ADDENDUM NO. 01

Project No.24076

Project Name: TFSD Lincoln HVAC Replacement
Address: Twin Falls, Idaho

Date Issued: March 27, 2025

Sheet No: D2.05

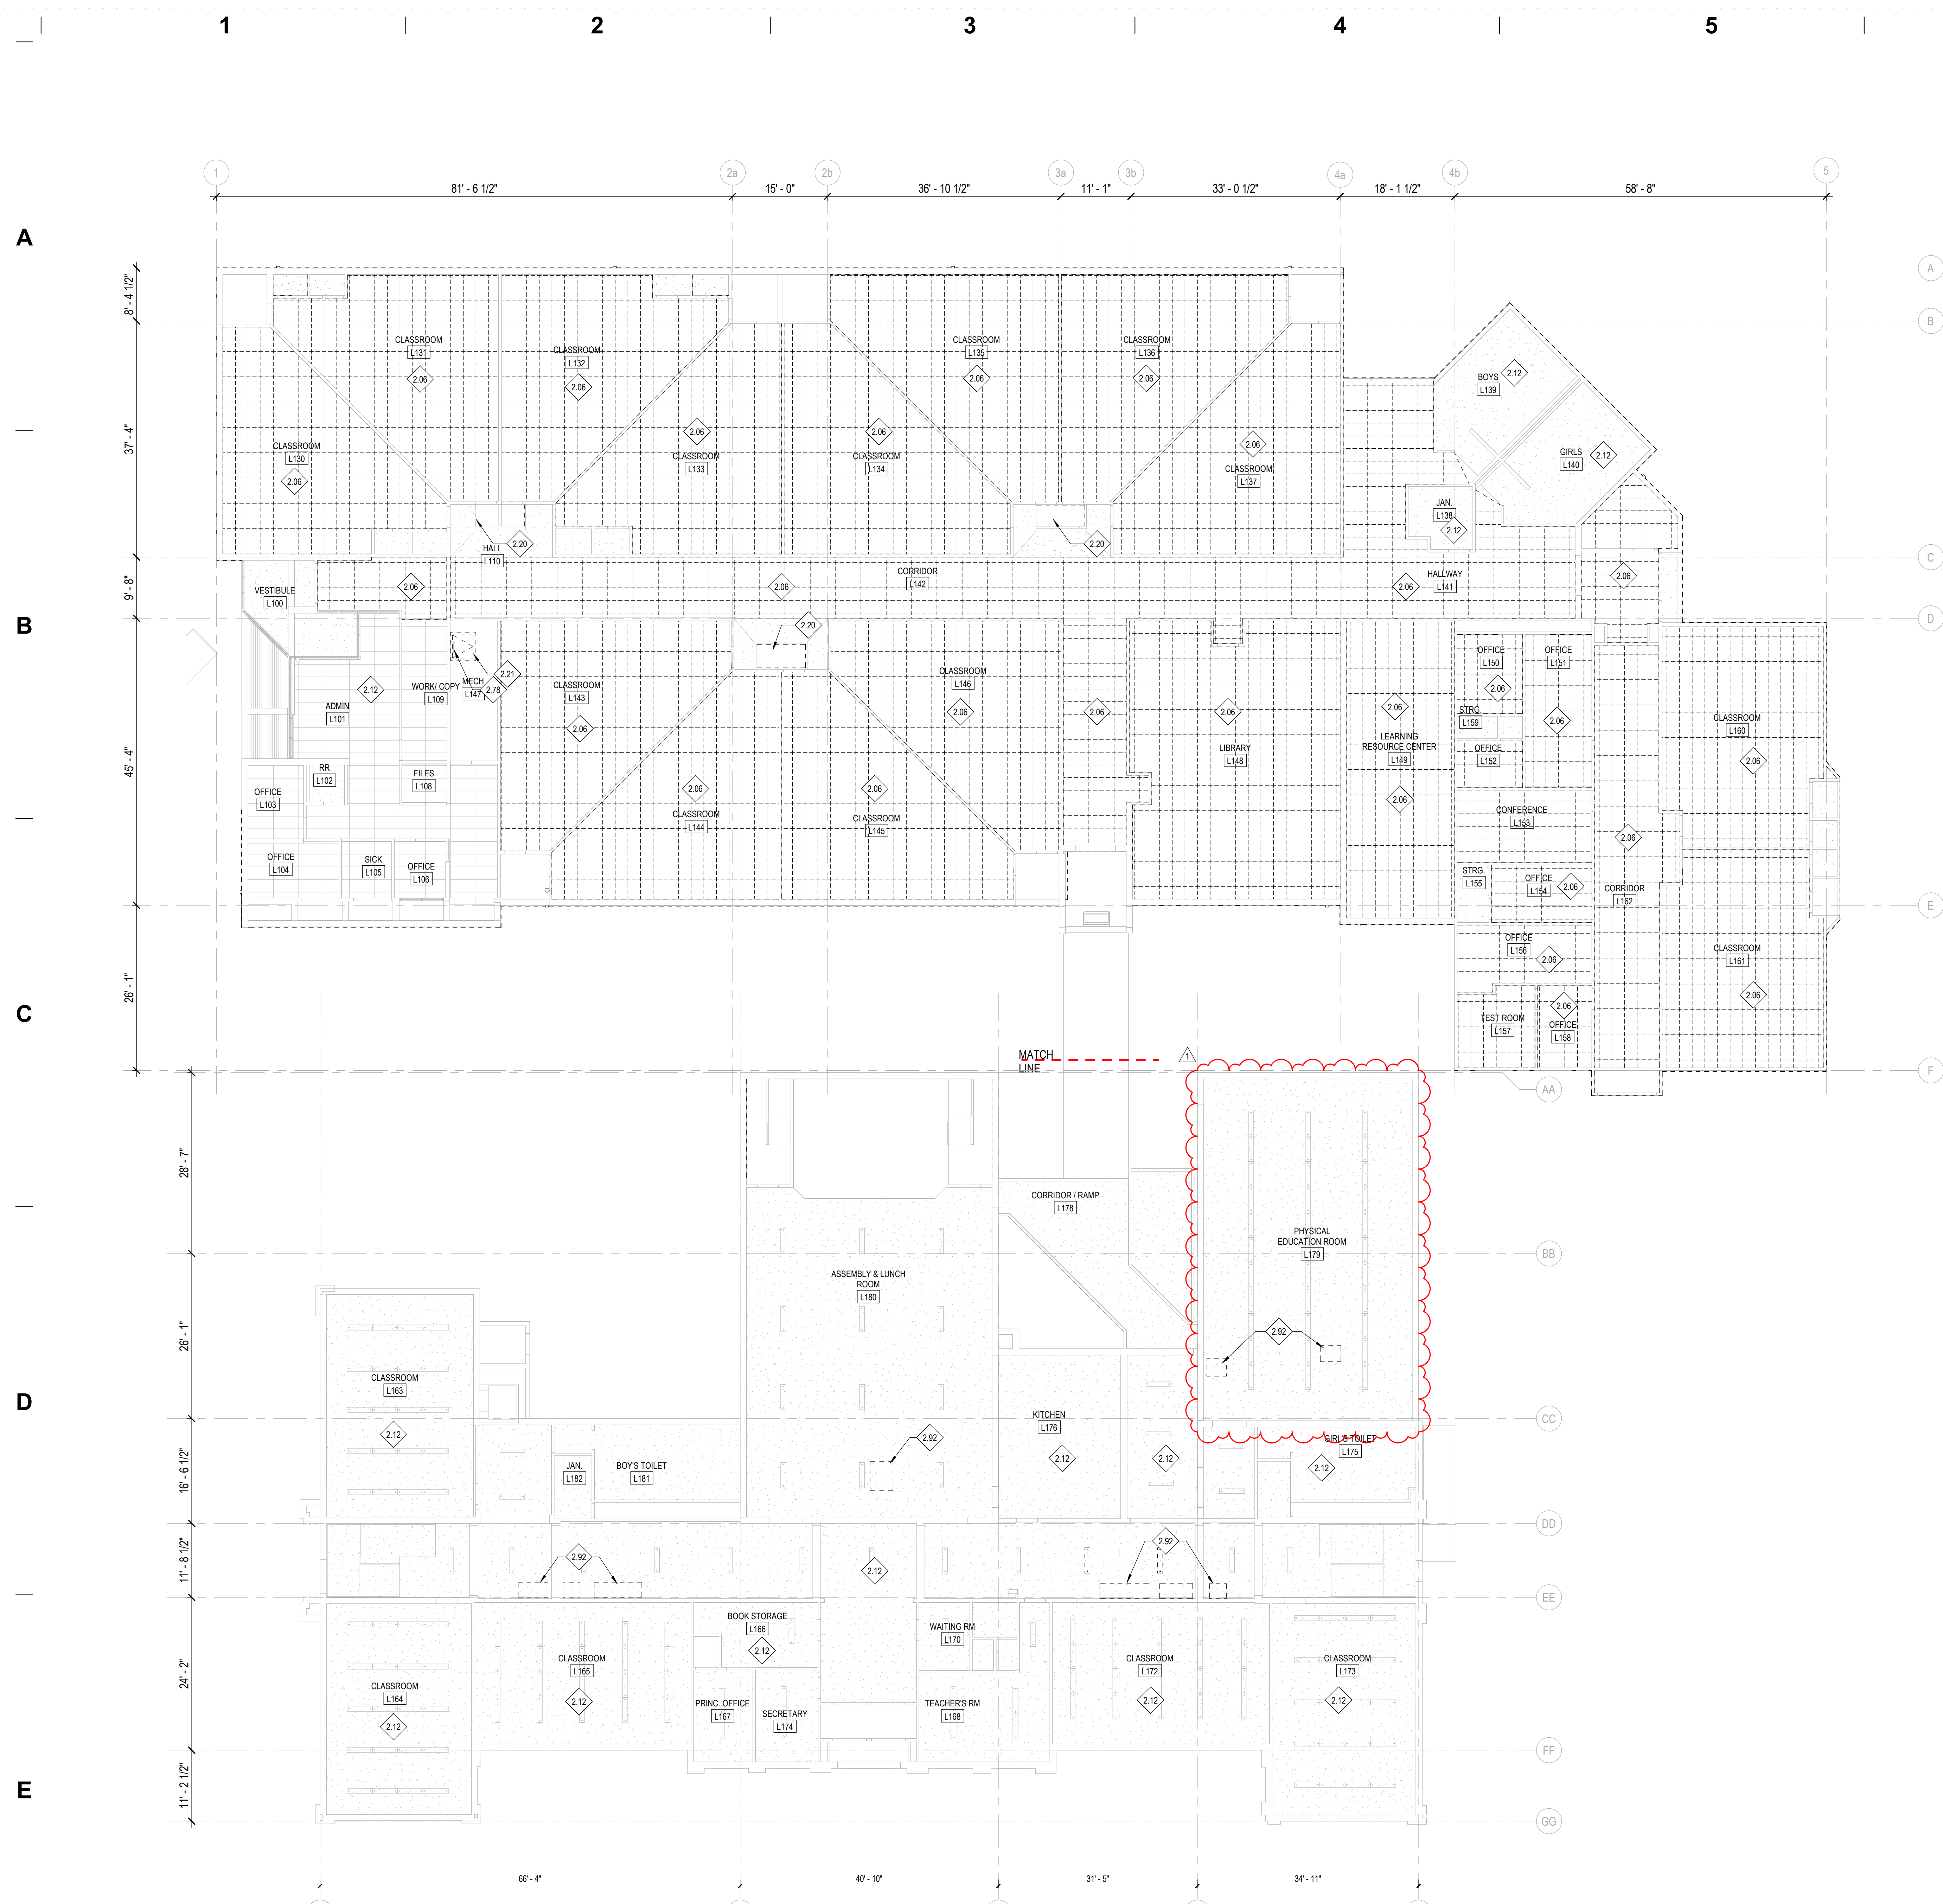
D2.05: LEVEL 01 - COMPOSITE DEMO REFLECTED CEILING PLAN

1. REVISED LIGHTING LOCATIONS AND DUCT PENETRATION LOCATION IN PHYSICAL EDUCATION ROOM.

Sheet No:
 D2.06

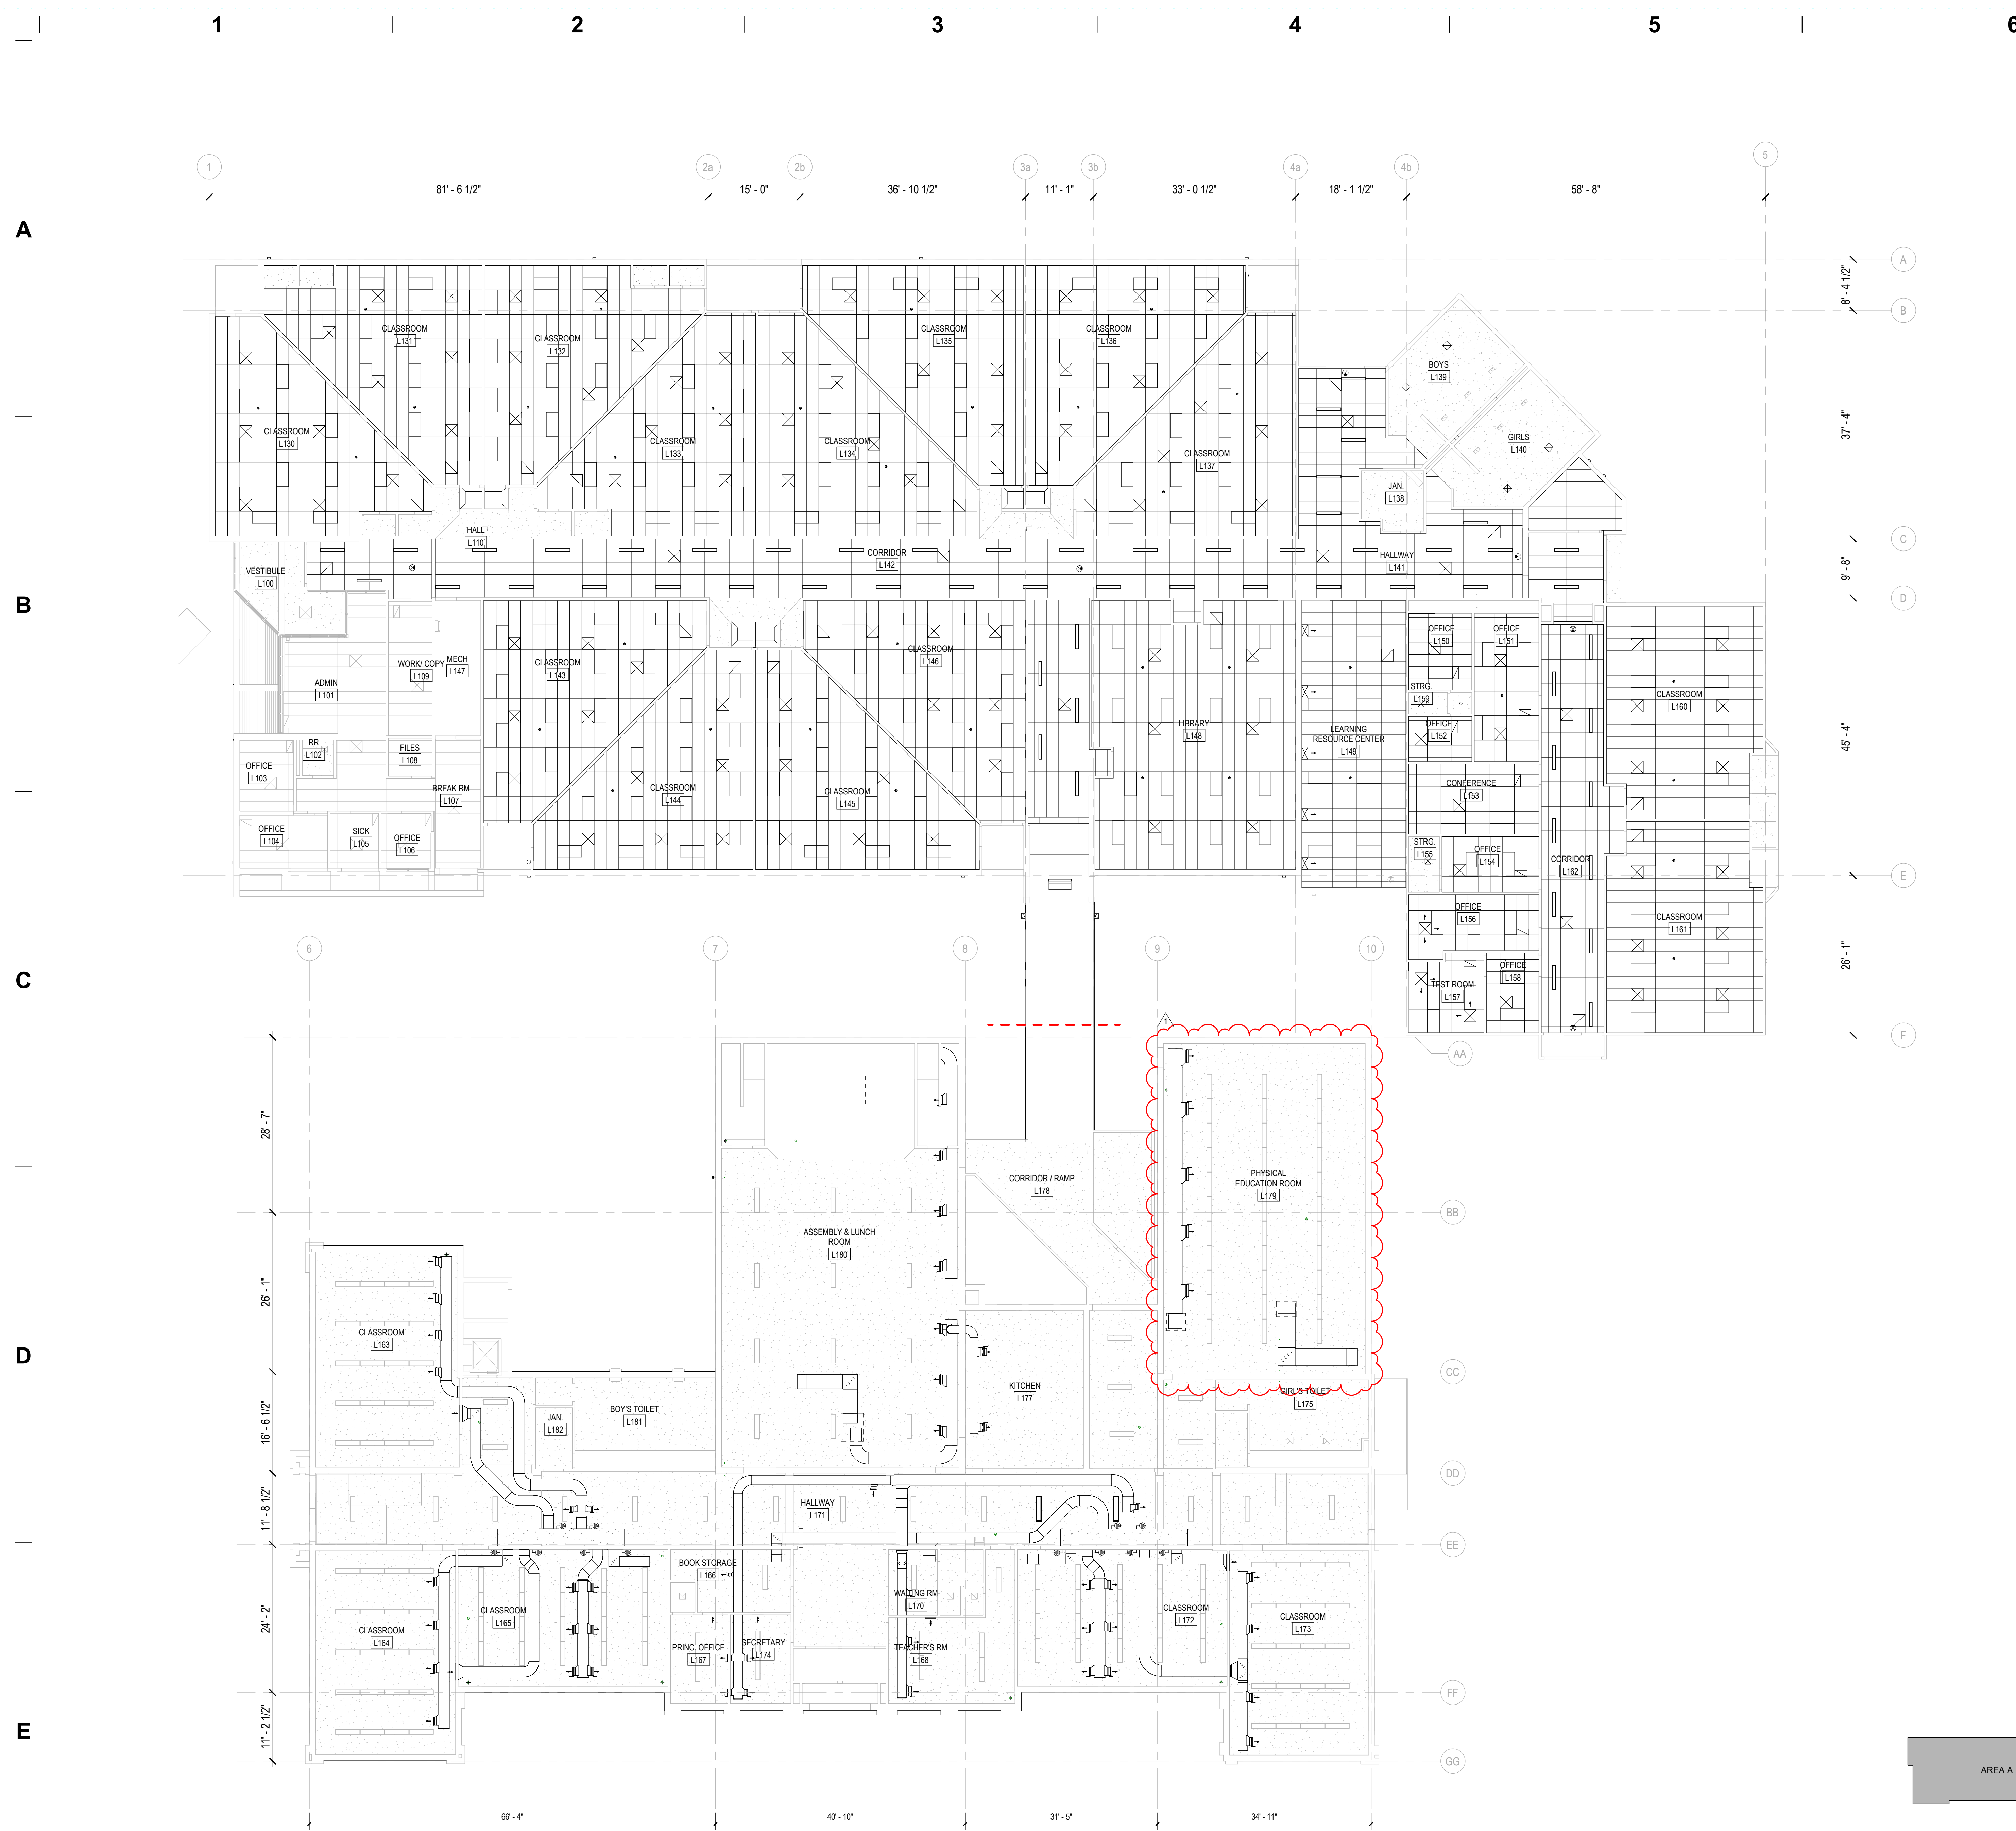
D2.06: LEVEL 02 - DEMO REFLECTED CEILING PLAN

1. REVISED LIGHTING LOCATIONS AND DUCT PENETRATION LOCATION IN THE PHYSICAL EDUCATION ROOM.

Sheet No: **A9.01**

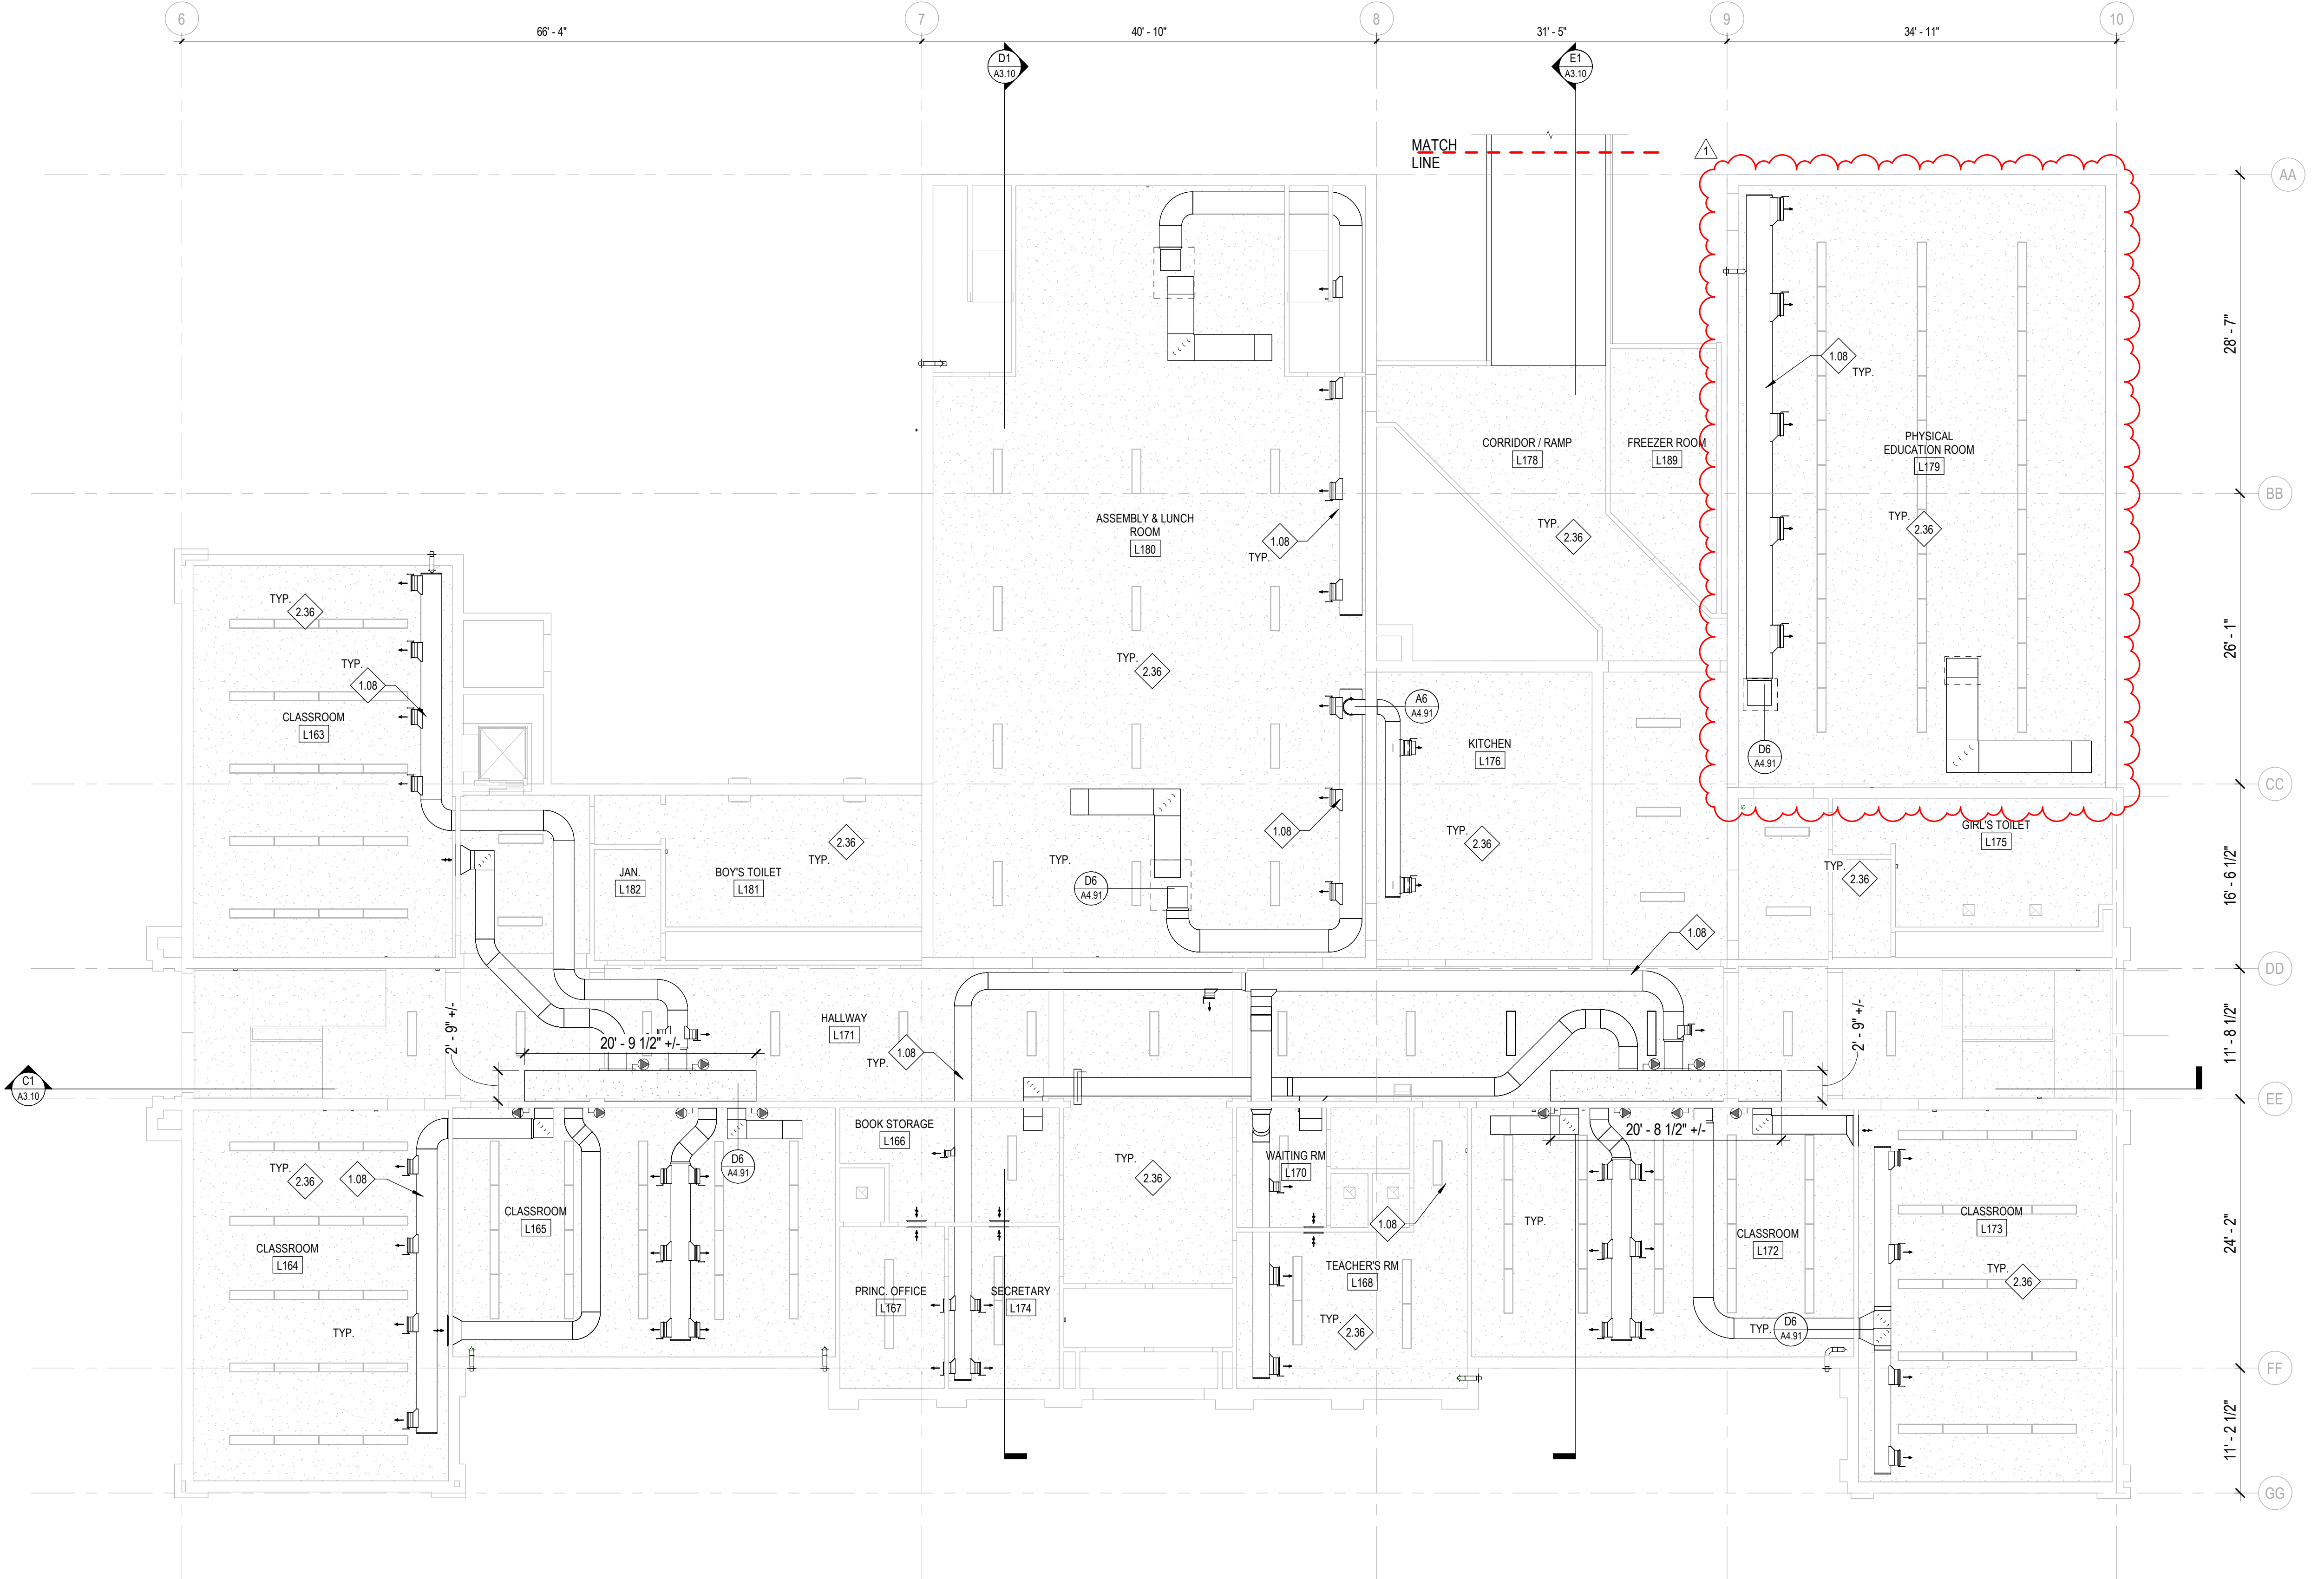
A9.01: LEVEL 01 - COMPOSITE CEILING PLAN

1. NEW DUCT ROUTE IN PHYSICAL EDUCATION ROOM.
